**Subject: Gelson's Public Comment - Add a lane to SB Sepulveda between 9<sup>th</sup> and 6<sup>th</sup> streets; use Bank for parking**

**Comment Letter PPPP****Response to Comment 1:**

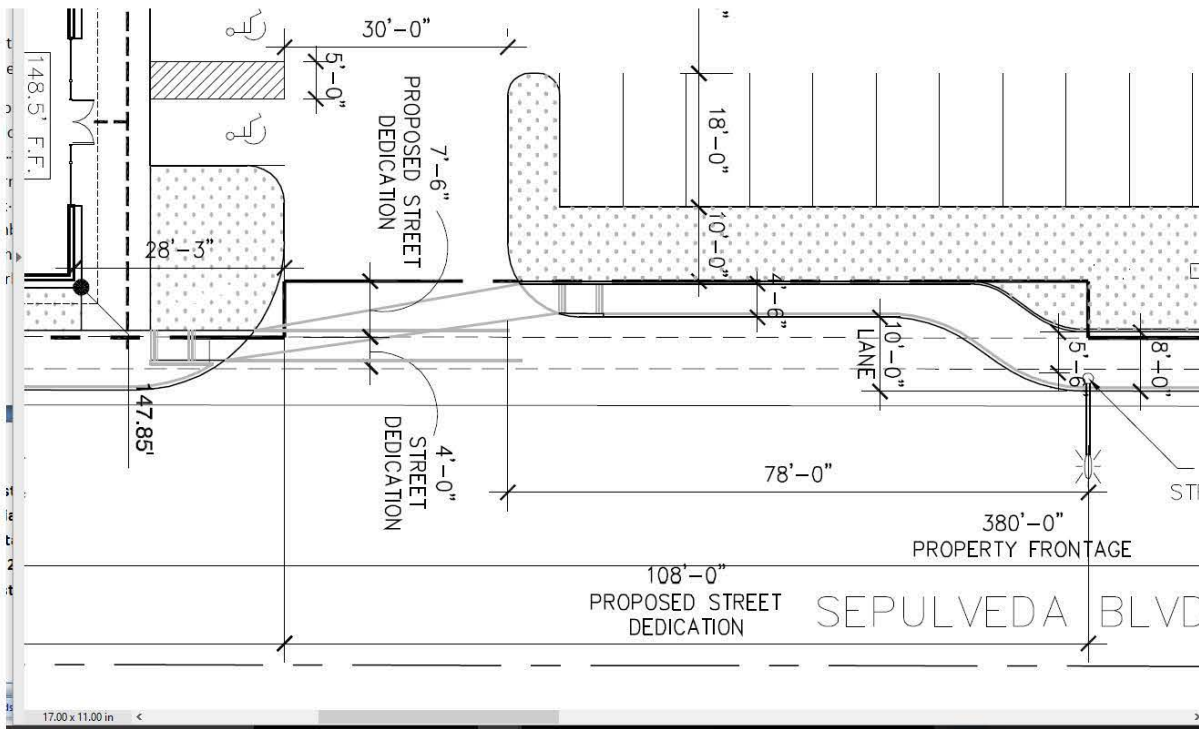
Suggestion 2: Add one lane the entire length between 8<sup>th</sup> and 6<sup>th</sup> street on the west side of Sepulveda for acceleration and deceleration

Require the developer to add an extra lane the entire length between 8<sup>th</sup> and 6<sup>th</sup> street on the west side of Sepulveda. This lane would provide two acceleration lanes and one deceleration lane as follows:

1. Cars turning right from 8<sup>th</sup> street onto Sepulveda south bound would have some distance to accelerate before merging into the southbound lane on Sepulveda.
2. Southbound cars on Sepulveda would have a longer distance than the 78-foot deceleration lane currently proposed by Gelson's to safely enter through the new entrance (which is located directly opposite 6<sup>th</sup> street on the east side of Sepulveda).
3. Cars turning right from the new exit from Gelson's onto Sepulveda southbound would have some distance to accelerate before merging into the southbound lane on Sepulveda.

The current proposed 78-foot decoration lane is much too short for traffic traveling at 35+ miles an hour to make a right hand turn into the Gelson's lot, especially if there are already cars stacked in front waiting to turn in. Turning traffic must also avoid pedestrians who might be crossing and must stay clear of exiting traffic that could be waiting to exit the parking lot. The entrance/exit lane is only 30 feet wide.

Table 8 and Table 9 of the IS/MND Traffic and Parking Study indicate that the proposed project would not have significant traffic impacts per City standards at the intersection of Sepulveda Boulevard/8<sup>th</sup> Street, nor at any of the other study intersections analyzed for the Study. Therefore, a longer deceleration/travel lane that is recommended by the commenter to be constructed between 8<sup>th</sup> Street and 6<sup>th</sup> Street would not be required as a project mitigation measure.

Refer to MR-3 regarding the deceleration lane recommended by the commenter for the Sepulveda Boulevard project driveway between 8<sup>th</sup> Street and 9<sup>th</sup> Street, and the widened shoulder that will be provided by the project, adjacent to the eastern frontage of the project site south of 8<sup>th</sup> Street.
